## Field Review Report

Project: xxxx

Report No.: x

Photograph 6

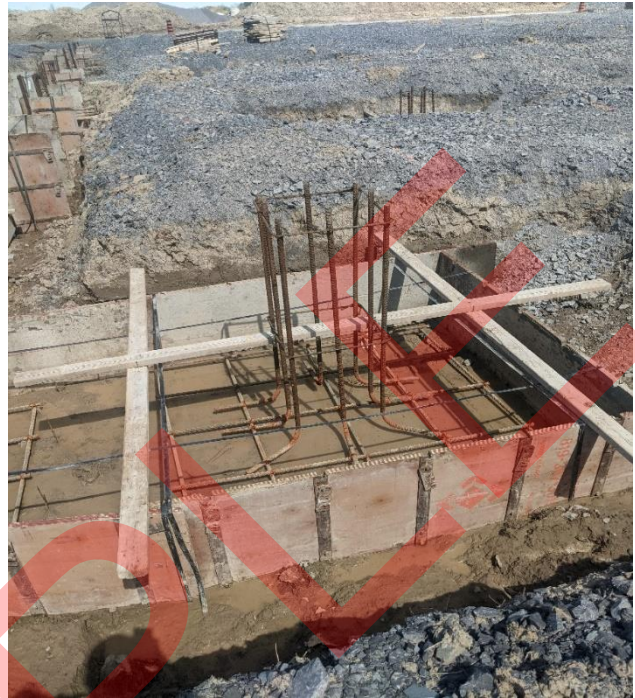
- Typical view of footing F5.
- The size and bars were installed as per plans.

Photograph 9

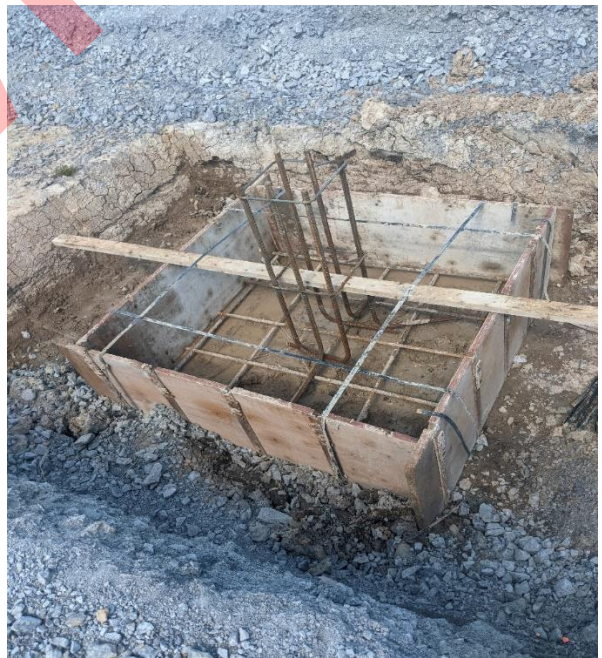
- Typical view of footing F6.
- The size and bars were installed as per plans.
